From: Sara Roediger, AICP
Date: 2/10/2015
Re: **Barrington Park PUD (City File #14-012)**
PUD Final Plan - Planning Review #2

From: Craig McEwen, R.A., Building Inspector/Plan Reviewer *CDN*
To: E. Anzek, S. Roediger, Planning Department
Date: January 28, 2015
Re: Barrington Park Final PUD Review #2, 15-26-376-007, City File #14-012

From: William Cooke, Lieutenant/Inspector
To: Planning Department
Date: February 4, 2015
Re: Barrington Park Final P.U.D.

To: Ed Anzek
Sara Roediger
From: Gerald Lee
Date: February 5, 2015
Re: Barrington Park Final P.U.D., Review #2
File #14-012

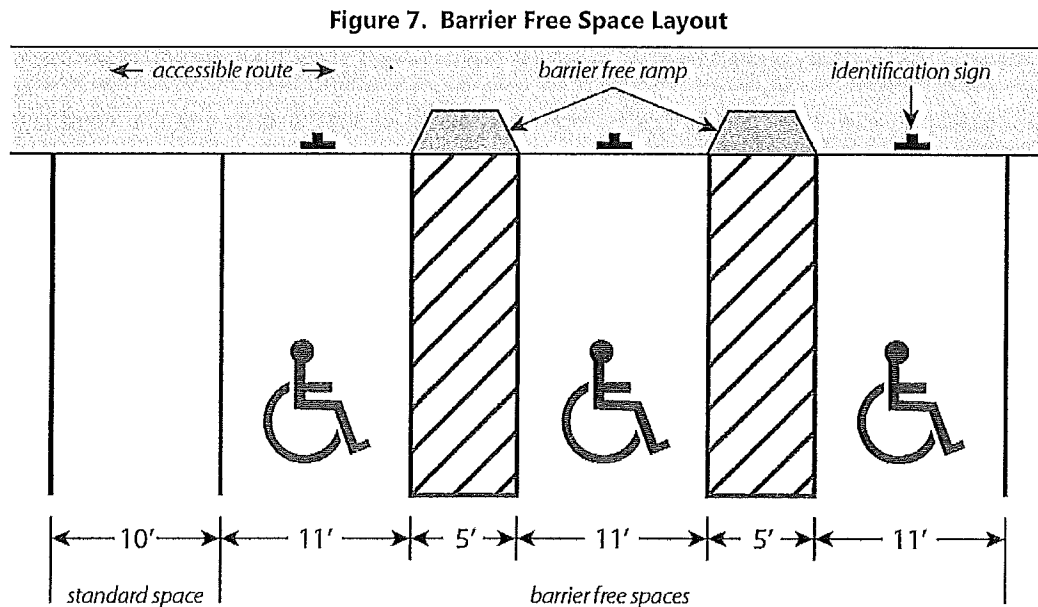
1. Provide accessible guest parking complying with ICC/ANSI A117.1-2003 and City of Rochester Hills Zoning Ordinance Section 138-11.300.
 - a. Provide 5 foot access aisle between accessible parking spaces at building 25 and 27. See attached.

- b. Expand grading details P and R to show both accessible parking spaces and access aisle. Grades in this area cannot exceed 2% in any direction.
2. Submission of detailed plot plans at the time of building permit application for each building showing code compliant grading and details.
